DART SERVICE INSTRUCTION

TO AMEND INSTALLATION INSTRUCTIONS D350-607-3 Rev.D,
INSTALLATION INSTRUCTIONS D350-607-4 Rev. C AND
INSTRUCTIONS FOR CONTINUED AIRWORTHINESS ICA-D350-607 REV. 6
REF TCCA STC: SH94-14
REF FAA STC: SR00213NY
REF EASA STC: EASA.10016996
REF BRAZILIAN STC: 2007S03-03/-04/-05/-06

FIGURE 1: INSTALLATION OF D4775-041 FWD STRUT

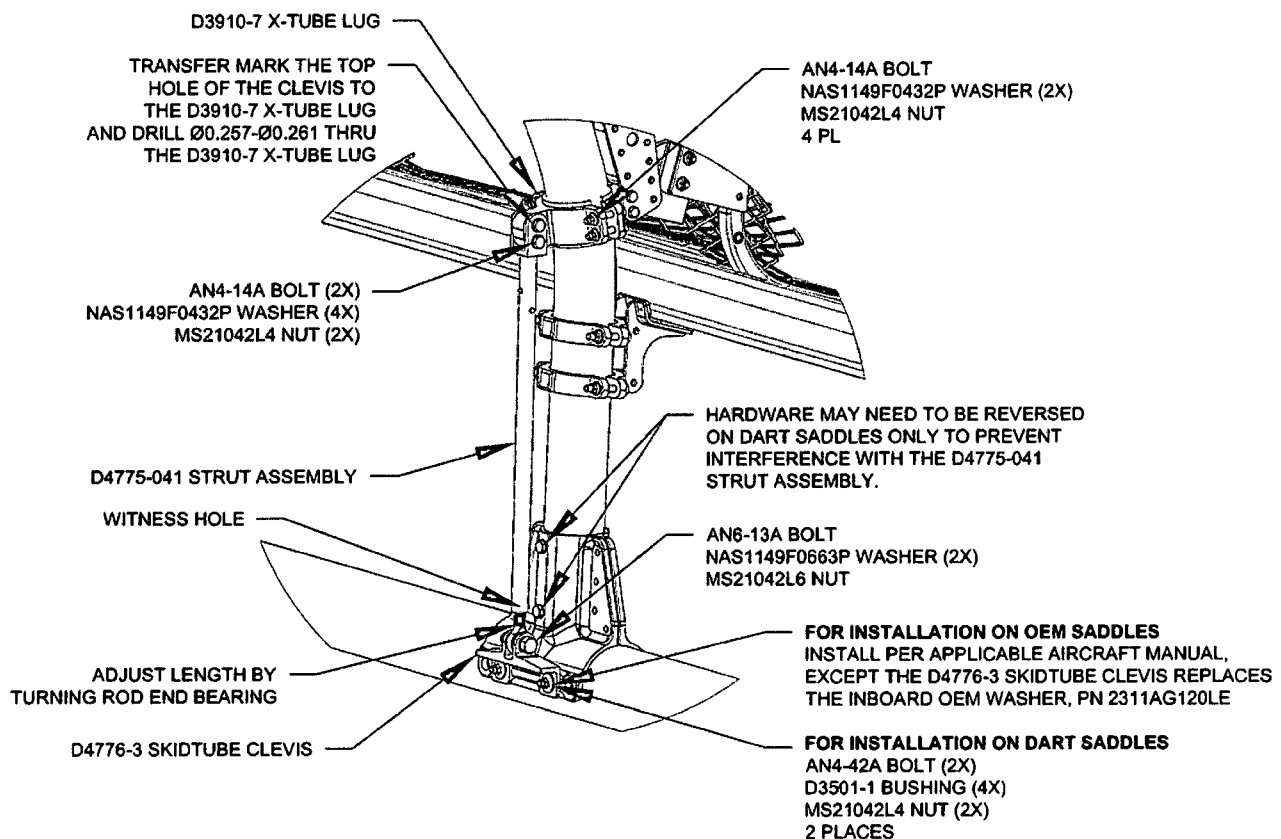
- 3.1 Substitute the Forward Lower D3910-5 X-Tube Lug with the D3910-7 X-Tube Lug as shown in Figure 1.
- 3.2 Install the forward D4775-041 Strut Assembly. Transfer mark from the upper hole on the clevis of the D4775-041 Strut Assembly to the D3910-7 X-tube Lug and drill thru the lug $\varnothing 0.257$ - $\varnothing 0.261$ as shown in Figure 1. Touch up chemical conversion coating per MIL-DTL-5541. Check the witness holes located at the bottom end of the D4775-041 Strut Assemblies to ensure that the thread from the rod end extends past the witness hole.
Torque MS21042L4/-4 nuts to 50-70 in-lbs (5.7-7.9 N-m). Torque MS21042L6/-6 nuts to 160-190 in-lbs (18.1-21.5 N-m).
- 3.3 Complete the installation in accordance with Installation Instructions D350-607-3 Rev. D or D350-607-4 Rev. C.
